UNIVERSITY ROW UNIT 2	
POADP	
PE ENGINEERING, INC. 8531 N. NEW BRAUNFELS, SUITE 107 SAN ANTONIO, TEXAS 78217 PHO: 822-6028	
REVISIONS No. Date Revision By	Project no.: Date: Drawn by: Checked by: Sheet no.

INFORMATION SHEET FOR
PRELIMINARY OVERALL AREA DEVELOPMENT PLAN
(P.O.A.D.P.)

Re: University ROW

File #: 85-11-63-64

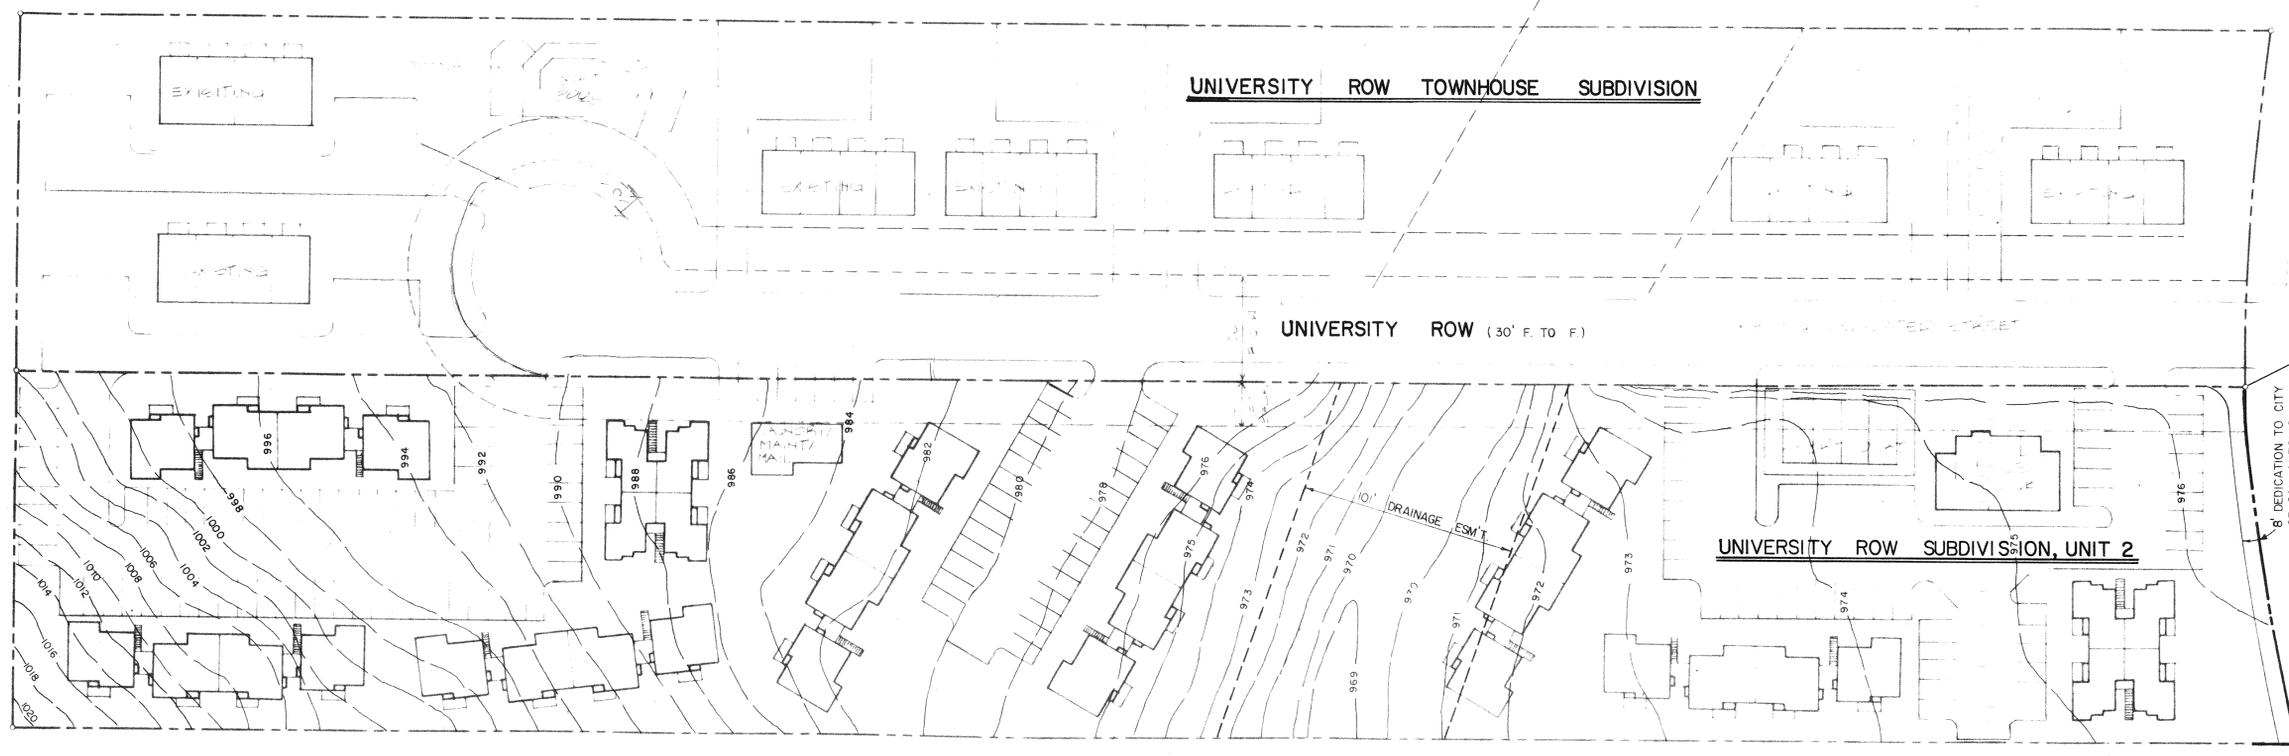
See annotations/comments on attached copy of your plan.

Comments: Upon formal plat filing, it will be necessary for you to obtain an approval letter from the Highway Department. In addition, Traffic will need to determine if additional R.O.W. is necessary along University Row.
